**ANGEL PLACE
LEVEL 8, 123 PITT STREET
SYDNEY NSW 2000**

31 August 2022

SECTION 4.55 (1A) MODIFICATION APPLICATION TO D2021/1483 - ASPECT VERN BARNETT SCHOOL

Figure 4 Architectural Plans modifications

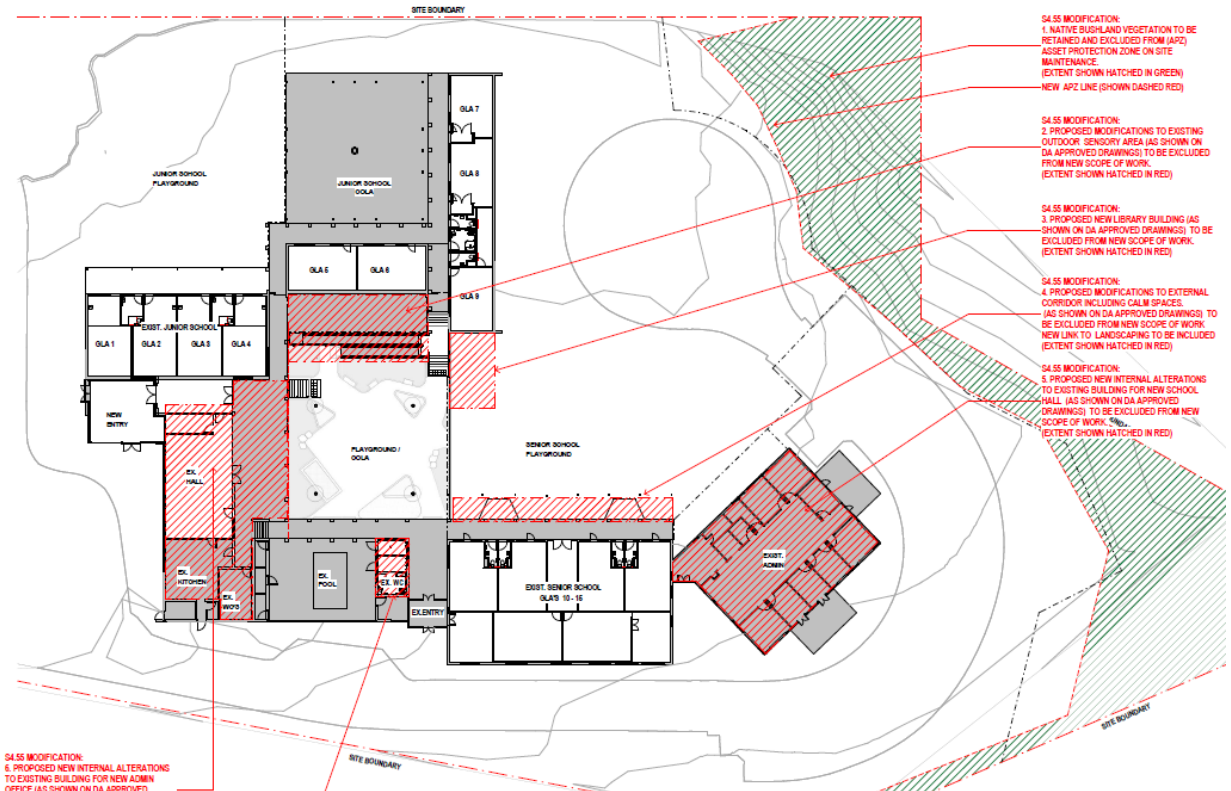
This modification application is seeking to remove some of the approved works under DA2021/1483 from the scope. This includes:

- Modifications to existing outdoor sensory area to be removed from the scope;
- Approved new library building to be removed from the scope;
- Modifications to external corridor including calm spaces to be removed from the scope;
- Approved new roof to calm spaces to be removed from the scope;
- Reduction to new verandah roof overhang over existing junior school;
- Internal alterations to existing building for a new school hall and new administration office is to be removed from the scope.

The removed scope is largely due to a reallocation of project funding and is shown in red hatching on the Architectural Plans at **Appendix A**.
